# UNITED STATES PATENT AND TRADEMARK OFFICE

APPLICATION NO.	FILING DATE	FIRST NAMED INVENTOR	ATTORNEY DOCKET NO.	CONFIRMATION NO.
10/698,536	10/31/2003	Percy A. Dickens	2826502.000001	9964
44777	7590	10/06/2005	EXAMINER	
W. EDWARD RAMAGE COMMERCE CENTER SUITE 1000 211 COMMERCE ST NASHVILLE, TN 37201			CHIN, PAUL T	
			ART UNIT	PAPER NUMBER
			3652

## Office Action Summary

## **DETAILED ACTION**

Exhibit A

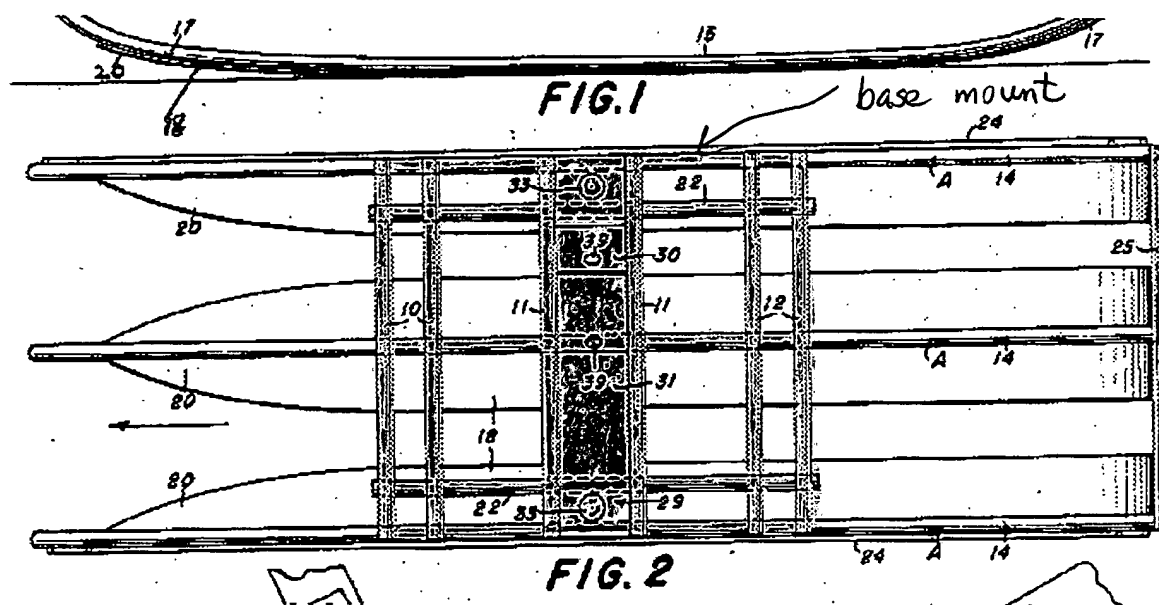
Griffith, Jr. (2,864,228) discloses a device for retrieving nuts comprising an elongated handle (36), a rectangular base mount (see exhibit A) affixed to on end of the handle, and a box shaped basket . Note that Exhibit A shows a rectangular shaped base mount and each substantially U-shaped rod being fixed to the first and second ends to the base mount wherein each rod is parallel to each other and the opposing ends are open.

Re claim 5, Exhibit A shows two rectangular pieces.
